SUBJECT: Amphenol Facility, Franklin, Indiana (96RC05-001)

Report of an Evaluation of the On-Site Recovery System

SUBJECT: Amphenol Facility, Franklin, Indiana (96RC05-001)

On-Site Recovery System Evaluation Work Plan

Figure 4. Locations of proposed Geoprobe sampling points.

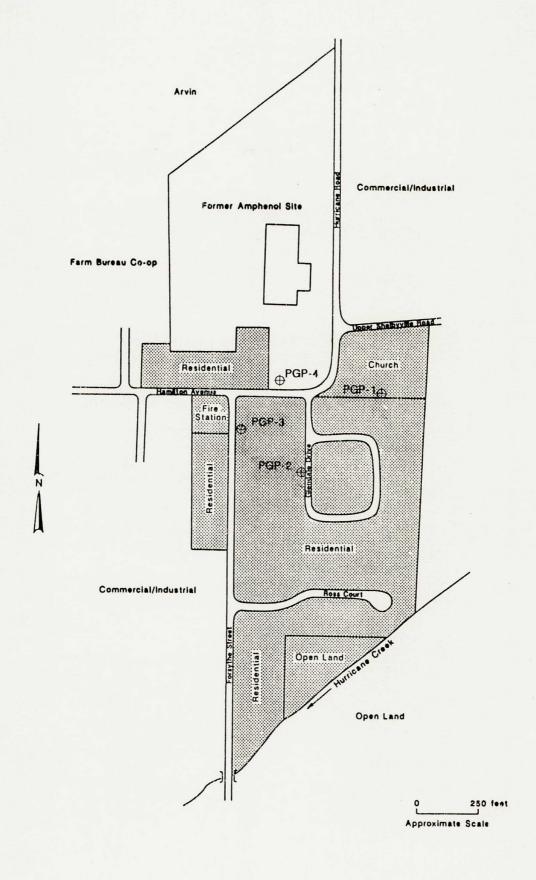
See Figure 4. Ground water samples are proposed at four locations: between former Geoprobe locations SGP-6 and SGP-7 (PGP-1), south of GNS-4 (PGP-2), the vicinity of the Forsythe Street - Hamilton Avenue intersection (PGP-3), and adjacent to MW-12 (PGP-4). The latter sample will be used as a check against standard screened well and
